NRC/DOE Technical Exchange on Yucca Mountain Pre-Licensing Issues

April 25-26, 2000

TECHNICAL EXCHANGE ON YUCCA MOUNTAIN PRE-LICENSING ISSUES

PURPOSE AND OBJECTIVE: To review the status, discuss and document the path forward for resolution of NRC Key Technical Issues; discuss role of Key Technical Issues in Sufficiency.

Need for Additional Data and Analysis

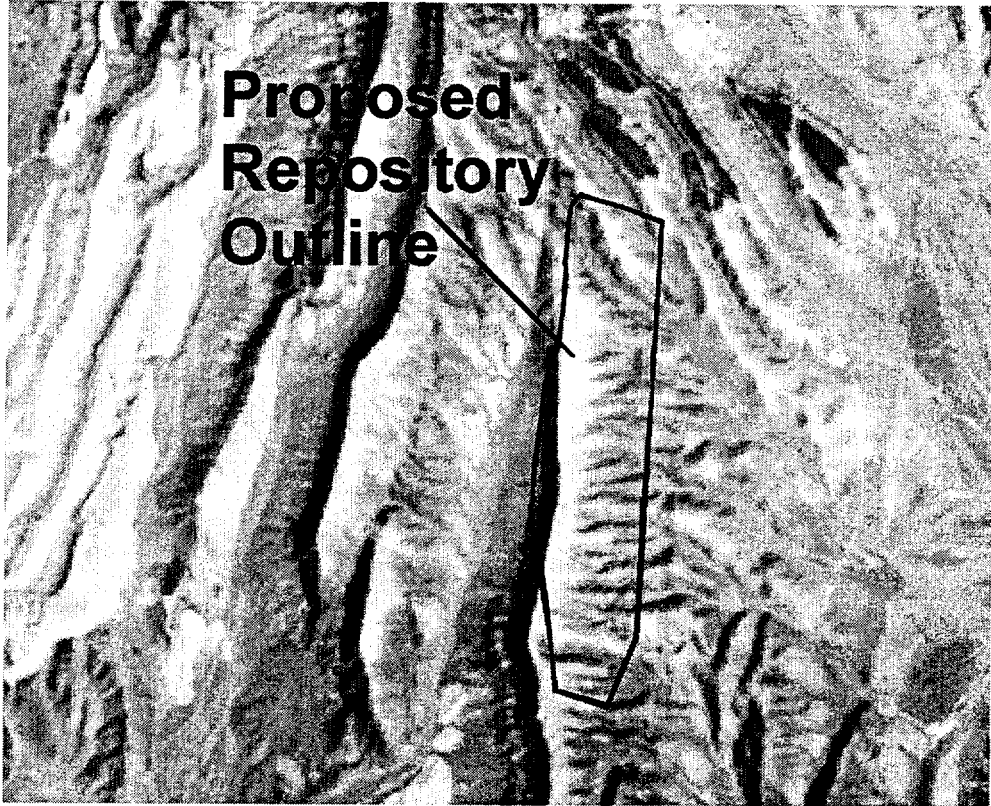
- **Determine UZ matrix moisture potentials under natural conditions (needed to calibrate UZ models)**
- **Justify key assumptions, or show they have little effect on performance**

Subissue 5: Saturated Zone and Dilution

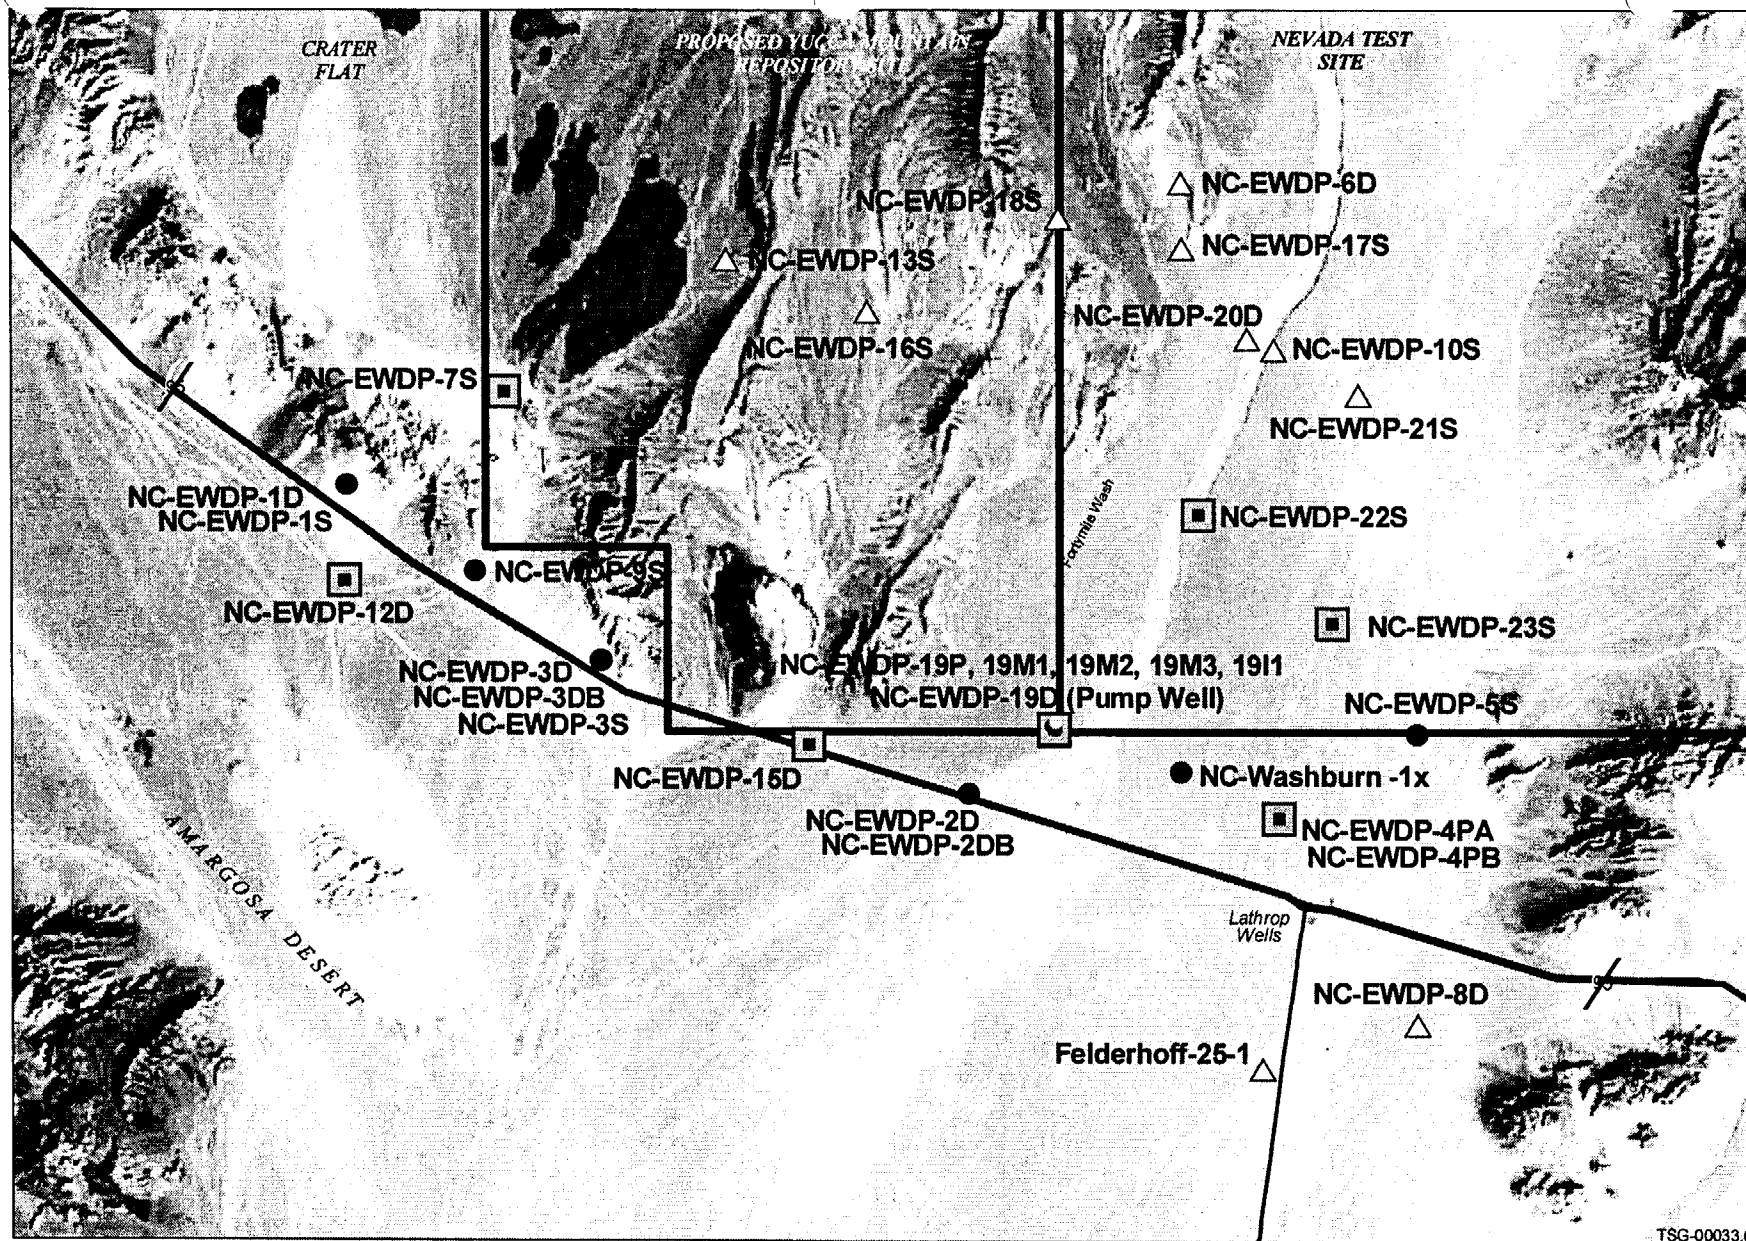
Properties of the SZ (especially alluvium) have a large effect on performance, and compliance must be shown at downgradient locations where groundwater is pumped from the SZ

Thermal-Mechanical Effects on Design of Underground Facility

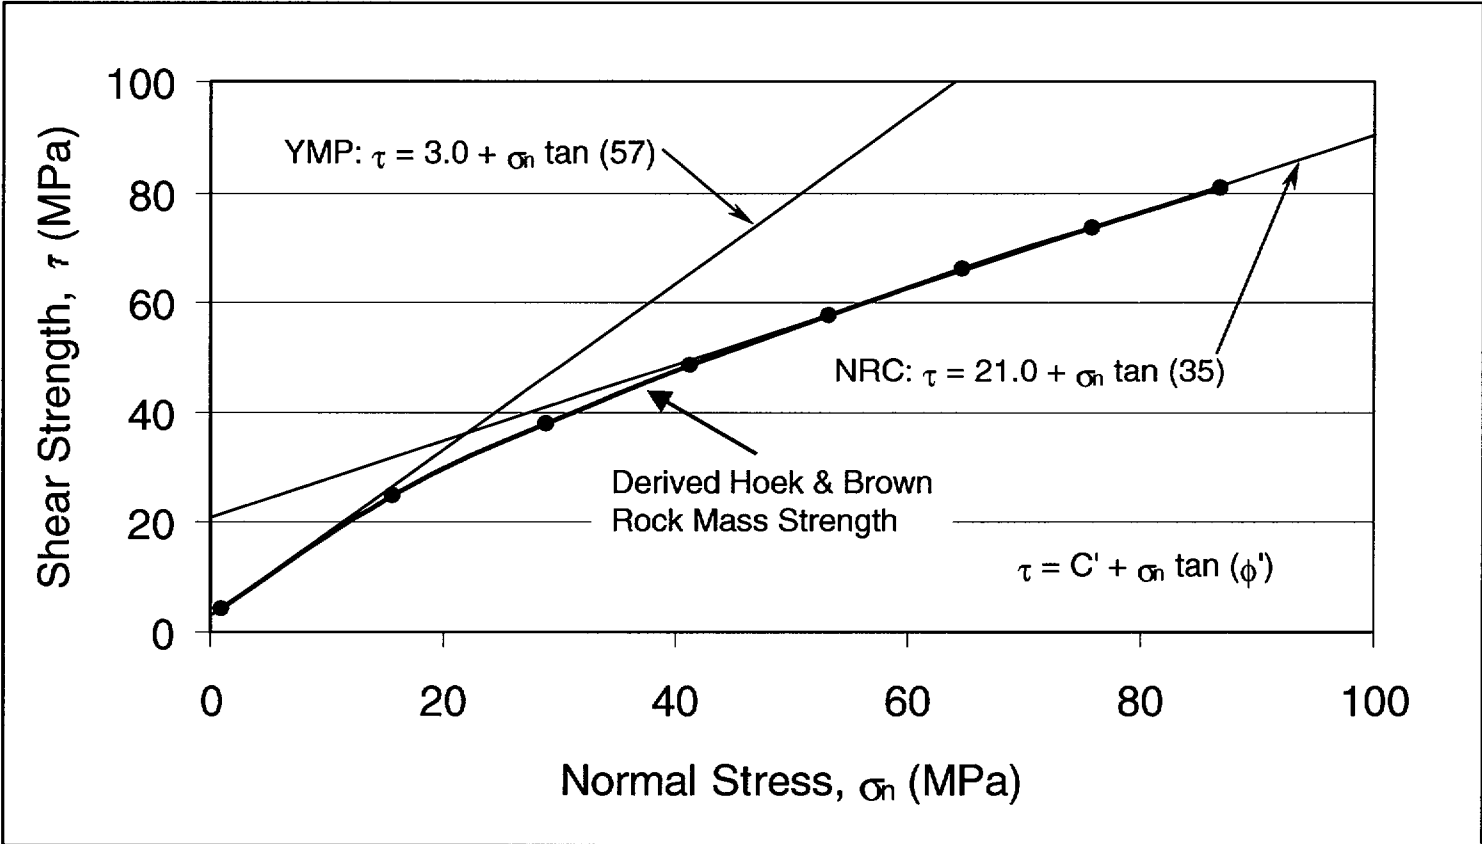
- Divergence of opinion related to predicted rock mass friction angles (IRSR, Section 4.3.3.2)
- DOE estimated rock mass properties based on geotechnical mapping of the rock mass following guidelines described by Hoek and Brown
- IRSR reports discrepancy in rock mass friction angles
 - DOE values: 57° to 58°
 - NRC values: 28° to 35°

Subissue 3: Does the DOE TSPA Adequately Account for Thermal Effects on Flow?

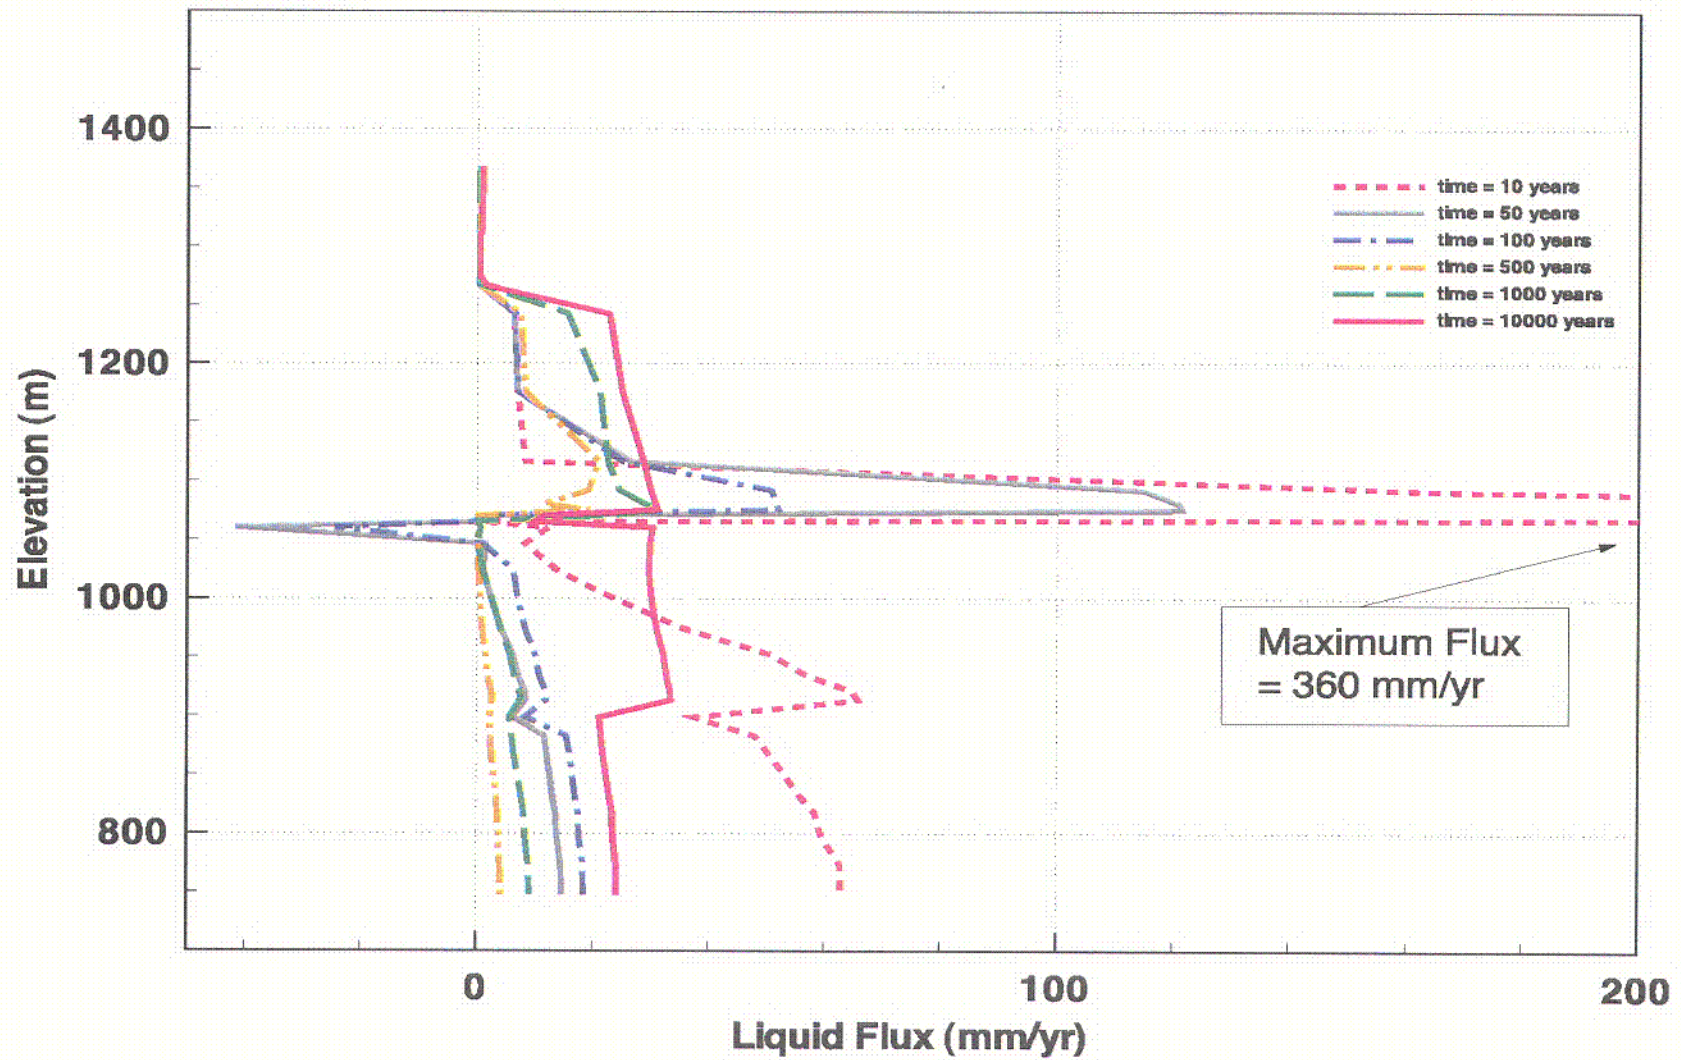
- **NRC considers issues open as a result of the heat and mass transfer issue in the Drift Scale Test**
- **Issue Resolution Status Report (IRSR) states that DOE has not yet demonstrated that the abstracted models used to bound process-level models, which predict water influx into an emplacement drift, are conservative**
- **IRSR states that process-level models do not yet incorporate all potentially important heat and mass transfer mechanisms**
